TEAC **TECHNICAL INFORMATION**

RW-800/CD-RW700/CD-RW2000, Change of Capacitor

No. **0206**
DATE 31st May 2002

Fig. 1 Pressure relief vent

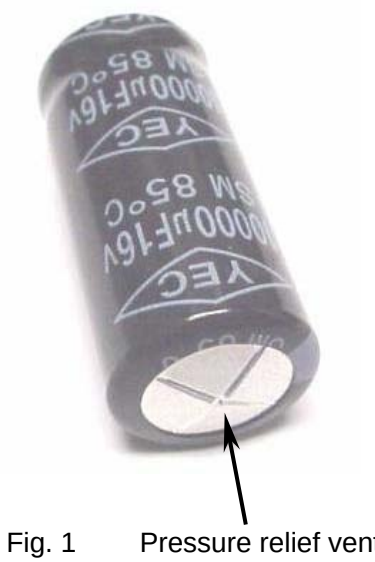
Additional Information
1. It has been reported that "pressure relief vent" of the defective C07 would open like Fig. 1.
2. C07 is fixed by an adhesive bond. This looks like a "leak" but not. See Fig. 2.
